OUT OF SCOPE ITEMS WORKSHOP SUMMARY

April 10, 2015

MOCA

LOT O AND AURORA AVENUE

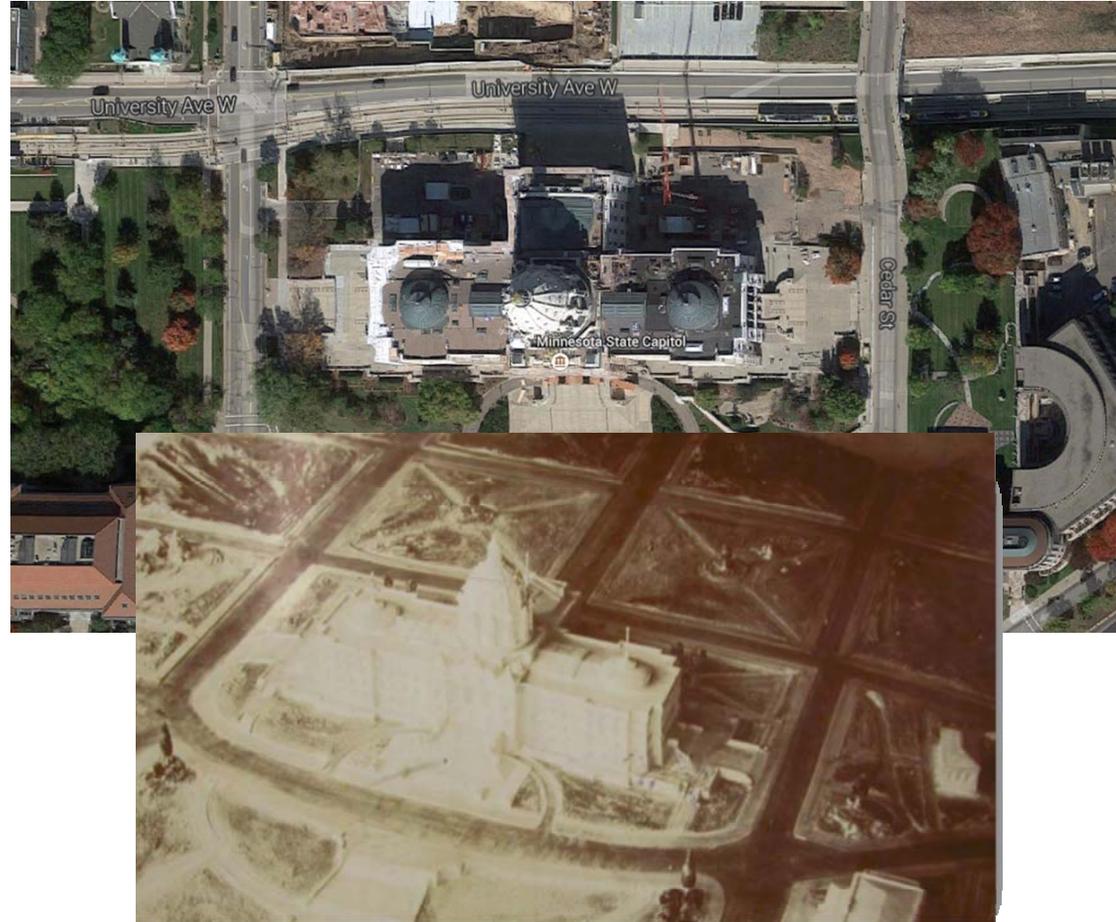
1. There was consensus that Aurora Avenue will not be used for school bus loading/unloading.
2. There was a general feeling that Aurora should be closed to all traffic and parking other than emergency vehicles.
3. ADA access was explained to be located at the South, East, and West entries.
4. The Senate currently pays for Aurora security personnel and would like to be relieved of that burden.
5. There was concern regarding the Admin Ramp and it's longetivety, displeasing aesthetics, and inconsistent architecture.
6. The design team was asked to study Aurora options without a traditional curb and gutter, in order to create a plaza atmosphere.

North Hall Decorative Paint

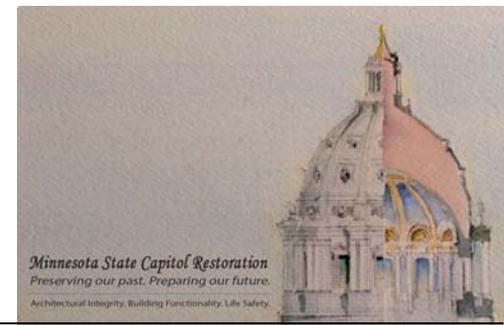
Participants were in agreement that the original decorative painting on the ceiling of the North Hall should be restored to its original design.

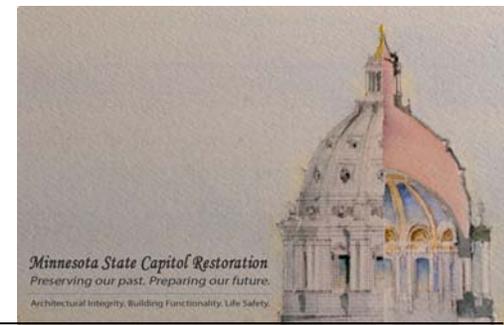
- Re-painting of the ceiling medallion in G15 restored to historic colors
- Painting of decorative striping in Ground Floor Corridors

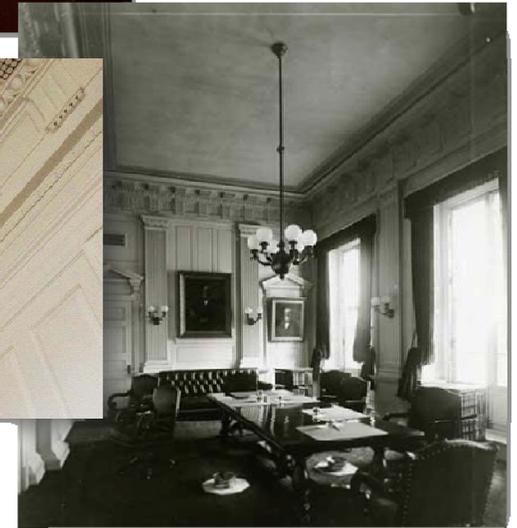
- Touch-up of gilding in the Supreme Courtroom.
- Replication of the historic Greek key ceiling border in the Supreme Court Conference Room.

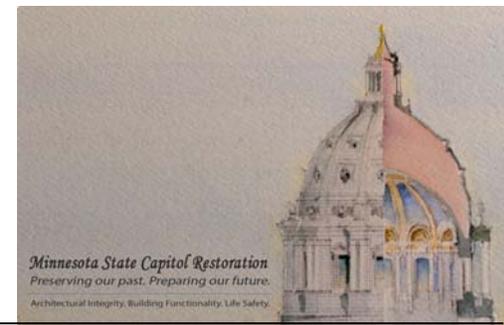
- Burnish Gilding and touch-up of the Pendentives in the Senate Chamber.
- Restore Decorative Paint areas in the Senate Retiring Room.

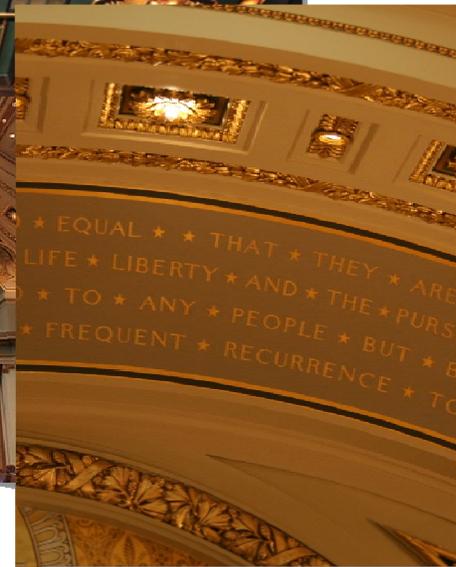
- Gilding of the ceiling decoration in the House retiring Room
- Gilding of the Letters above the Dais in the House Chamber.

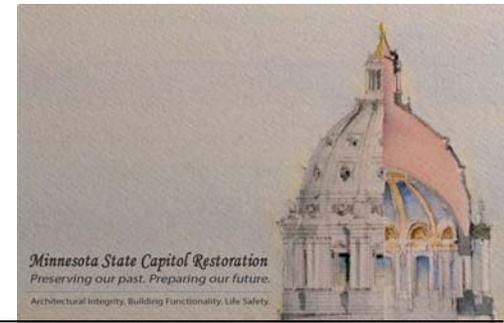
- Gilding of the ceiling borders to replicate historic finishes in the Governor's Office and the Governor's Conference Room.

South Loggia

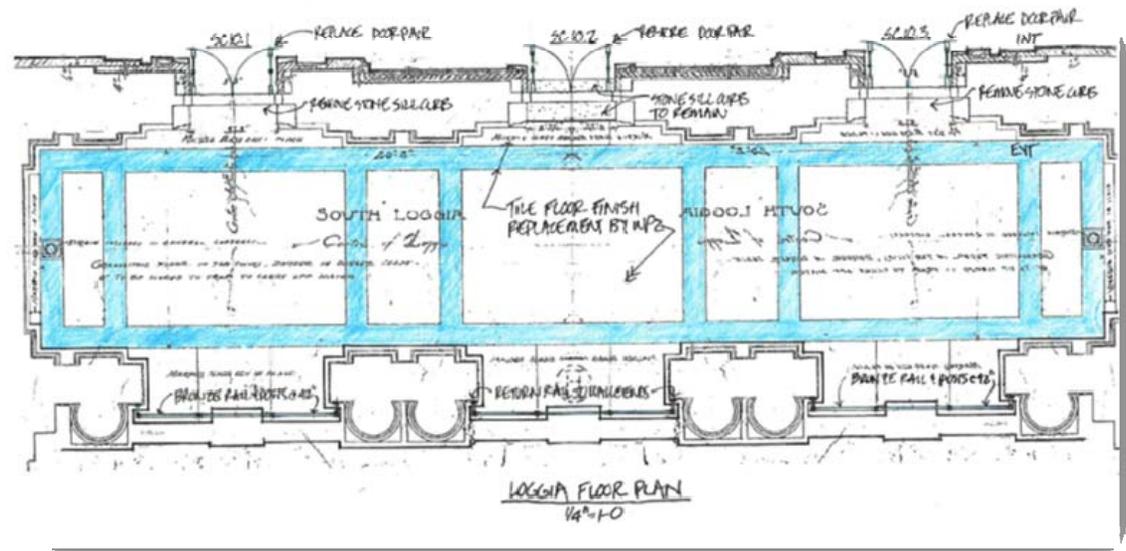
Approved work plans include restoration of Loggia stonework but not ADA accommodations needed to reopen the Loggia, including:

- New French Doors would replace re-stored existing.
- New hardware systems would replace restored/replica hardware.
- New railing would be added to meet code requirements for railing heights.
- Existing construction
- Barrier-free access
- Code implications
- Impacts on historic fabric
- Hardware requirements
- Security considerations
- Policy issues regarding use

SOUTH LOGGIA

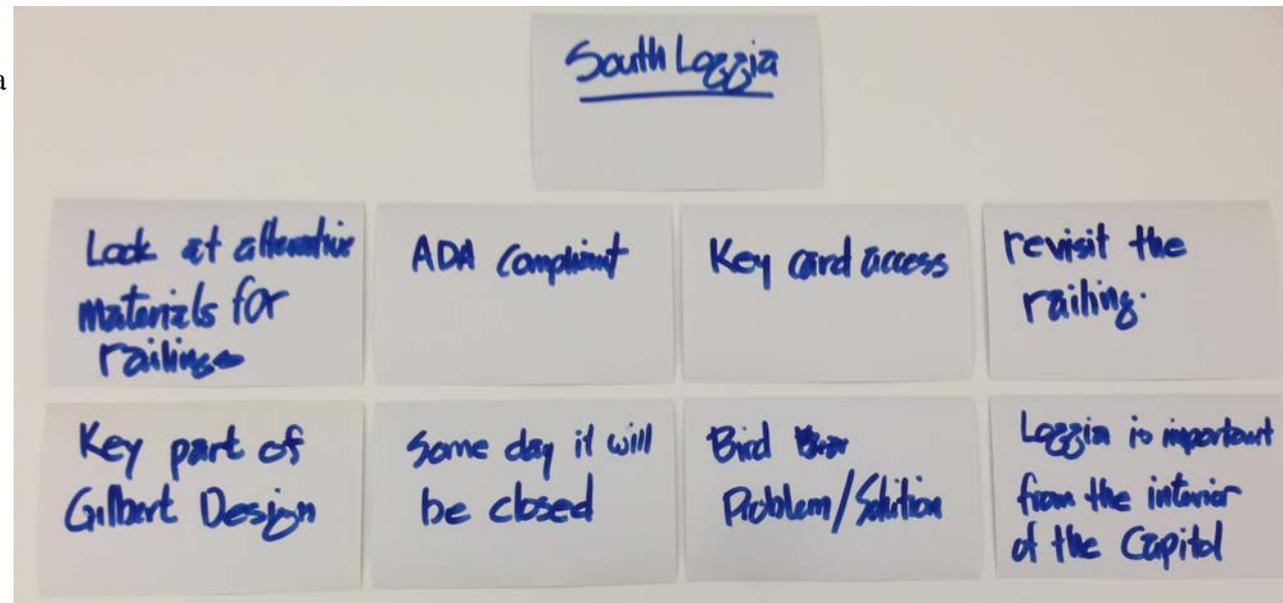
There was not consensus regarding whether to reopen the South Loggia and it was agreed that this item needs further discussion and consideration. Items discussed included:

- Members asked if we needed to change the balustrade, and it was explained that a brass rail could be added without alteration to the historic balustrade.
- Members cautioned that Brass could appear dingy without proper maintenance and suggested glass.
- Members that supported reopening the Loggia cited it's additional square footage, it's cherished place in the Capitol, and it's unique views.
- Members arguing against cited pigeon roosting, safety concerns, and the potential for interest groups to occupy the space and hang banners over the railing.

East Wing
Great Hall
Floor

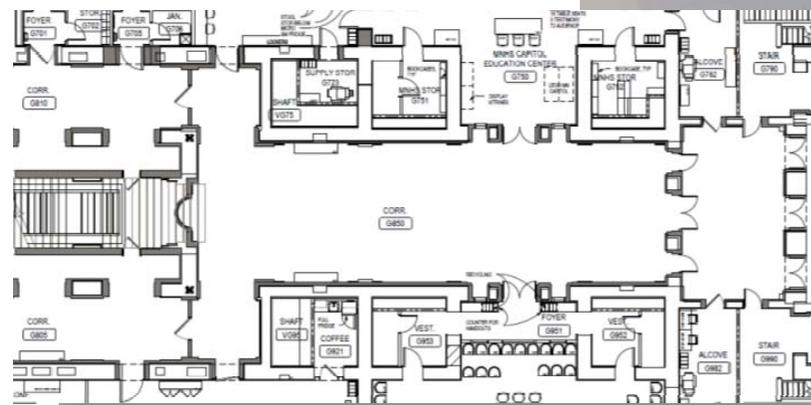
Approved work plans provide for concrete flooring in the Great Hall. The group discussed the following:

- Participants asked if wood (the historically correct material) was an option. The design team explained that maintenance in such a high traffic area would be cumbersome.
 - Participants mentioned that this space could potentially be a reservable event space.
 - The Stone was discussed as the most appropriate solution.

There was a consensus among the group that the stone flooring should be supported by the commission.

Use stone - not
Carpet or Wood

Crown/Cove
molding

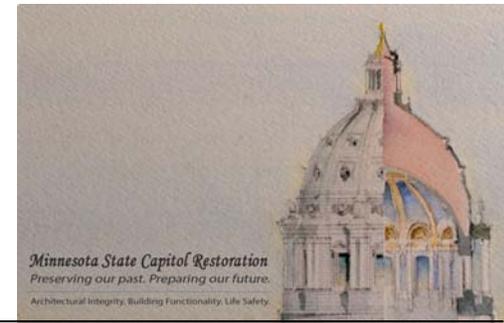
- Members asked if picture frame or art hanging could be incorporated in to the cove molding. The design team agreed to look in to this possibility.

There was a consensus from the group that the Cove Molding in historically correct areas should be supported by the Commission.

incorporate
picture railing
in new Cove molding
